GAME - Team UPDATE - 2012-04-17	3
GAME - Team UPDATE - 2012-04-03	4
GAME - Team UPDATE - 2012-03-27	5
GAME - Team UPDATE - 2012-03-20	6
GAME - Team UPDATE - 2012-03-14	7
GAME - Team UPDATE - 2012-03-13	8
GAME - Team UPDATE - 2012-03-06	9
GAME - Team UPDATE - 2012-02-28	12
GAME - Team UPDATE - 2012-02-24	14
GAME - Team UPDATE - 2012-02-21	15
GAME - Team UPDATE - 2012-02-17	16
GAME - Team UPDATE - 2012-02-14	17
GAME - Team UPDATE - 2012-02-10	19
GAME - Team UPDATE - 2012-02-07	20
GAME - Team UPDATE - 2012-02-03	21
GAME - Team UPDATE - 2012-01-31	22
GAME - Team UPDATE - 2012-01-27	24
GAME - Team UPDATE - 2012-01-24	25
GAME - Team UPDATE - 2012-01-20	27
GAME - Team UPDATE - 2012-01-17	30
GAME - Team UPDATE - 2012-01-13	31
GAME - Team UPDATE - 2012-01-10	35
ADMINISTRATIVE - Team UPDATE - 2012-03-13	41
ADMINISTRATIVE - Team UPDATE - 2012-02-24	42
ADMINISTRATIVE - Team UPDATE - 2012-02-03	43
ADMINISTRATIVE - Team UPDATE - 2012-01-20	44

GAME - Team UPDATE - 2012-04-17

Figure 4-8

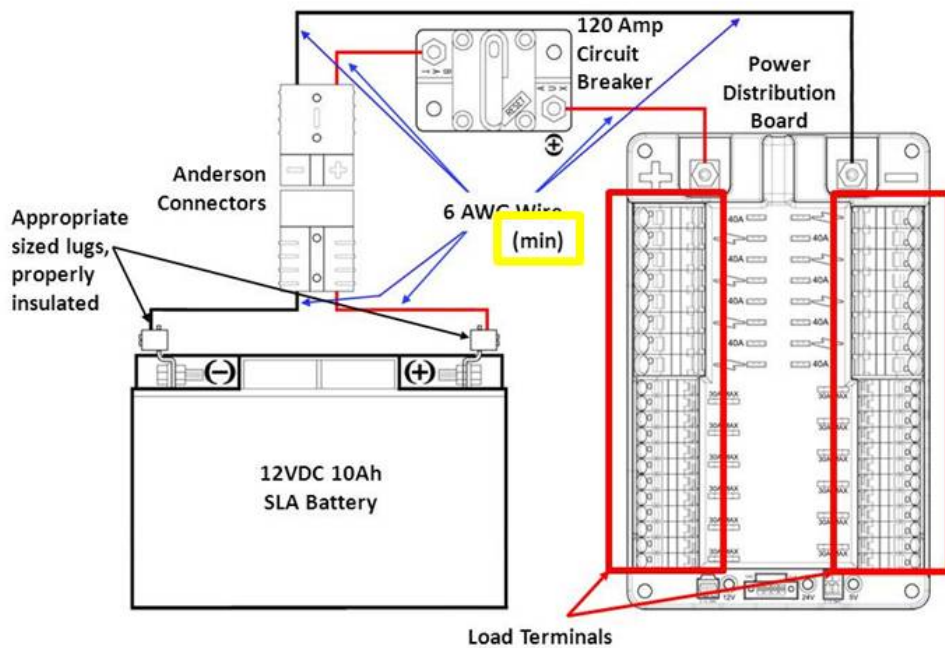
Figure 4-8 was revised to allow wire larger than 6AWG between the battery terminals and the Power Distribution Board terminals.

Figure 4-3

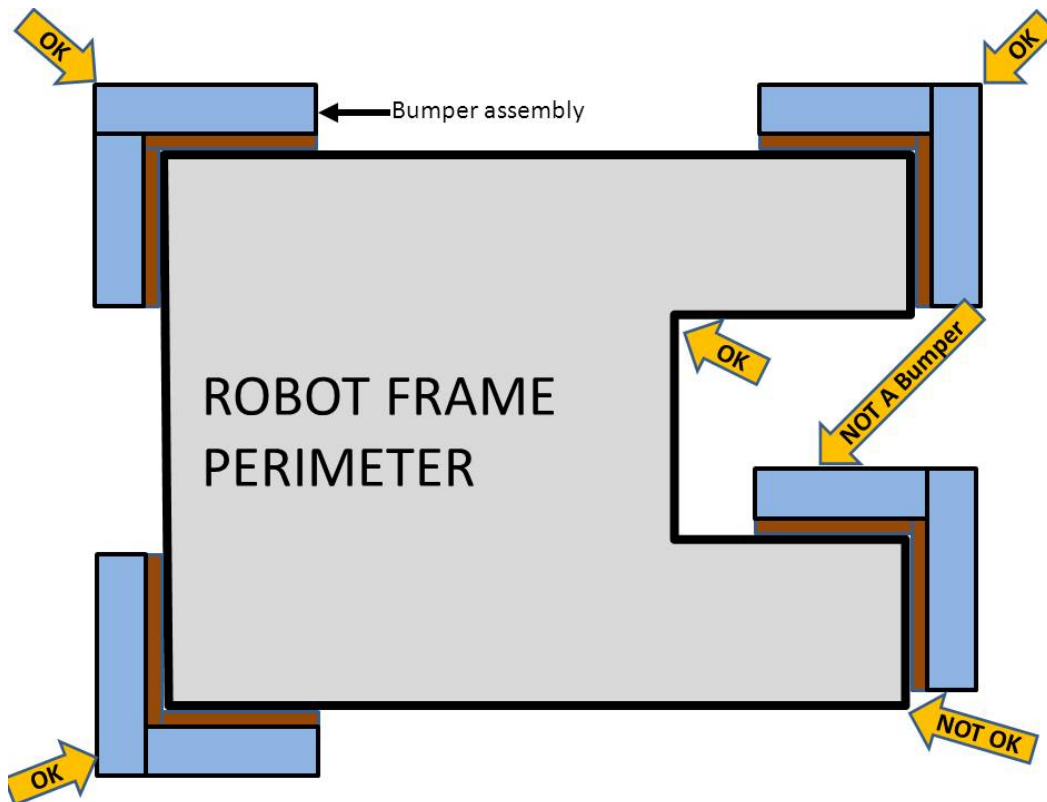
Figure 4-3 has been revised to clarify that example padding is legal, but not considered an official Bumper based on its placement.
